Date: 11/22/99
Subject: Better Brte
FIGURES

# of Copies	Item
1	Zinc Shop Foundation Drain Layout
1	Zinc Shop Utility Layout
1	Diagram of Wedge under Storm Drain
1	Treatment Building As-Built
1	Chrome shop storm Drain Location west side

BETTER BRITE REMEDIAL ACTION DePERE, WISCONSIN	DATE: 11/21/99
	DESIGNED: RAG
STORM DRAIN LAYOUT CHROME SHOP	CHECKED: KEB
	APPROVED: PRC
	DRAWN: RAG
	PROJ: F076
Figure

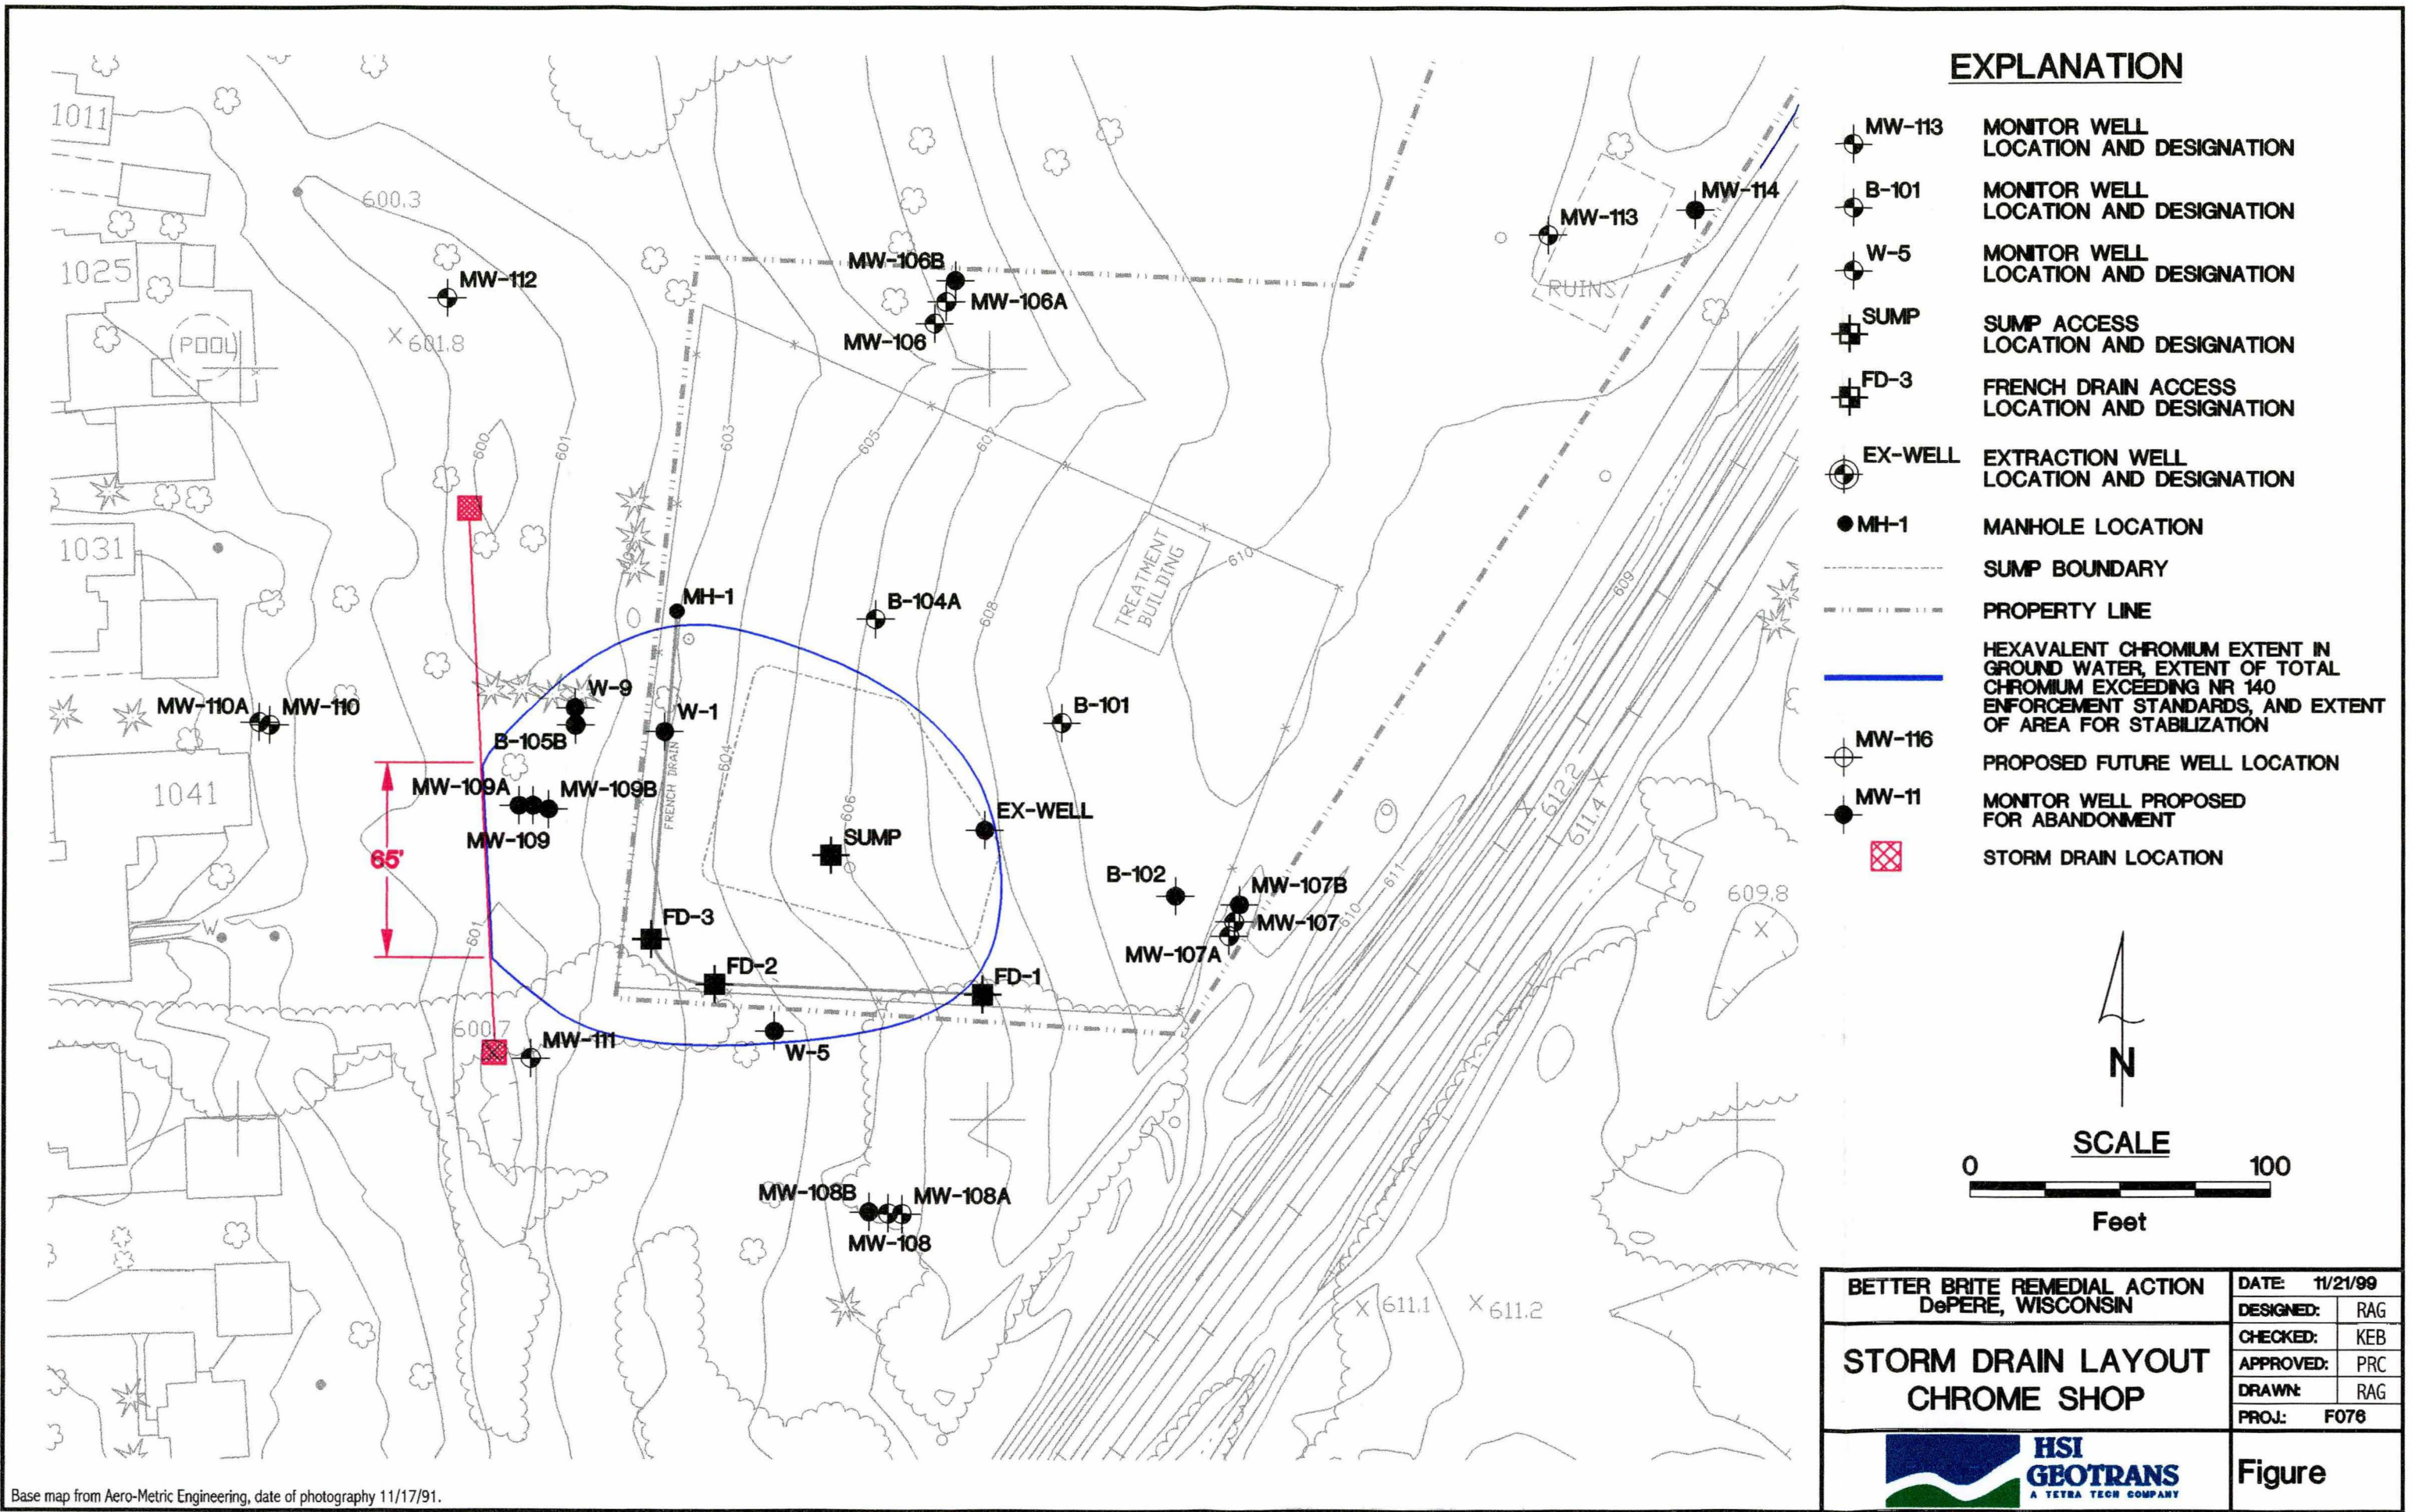
$$\frac{65 \times 15 \times 3.75}{2} = 1828.125$$

This is the area that Keith measured out for the soil not stabilized due to the presence of the storm sewer. We can up the volume from 60 CY to 70 CY (justifiably) on the change order.

$$\frac{28.125}{27} = \underline{\underline{67.7}} \text{ Cubic yards of soil}$$
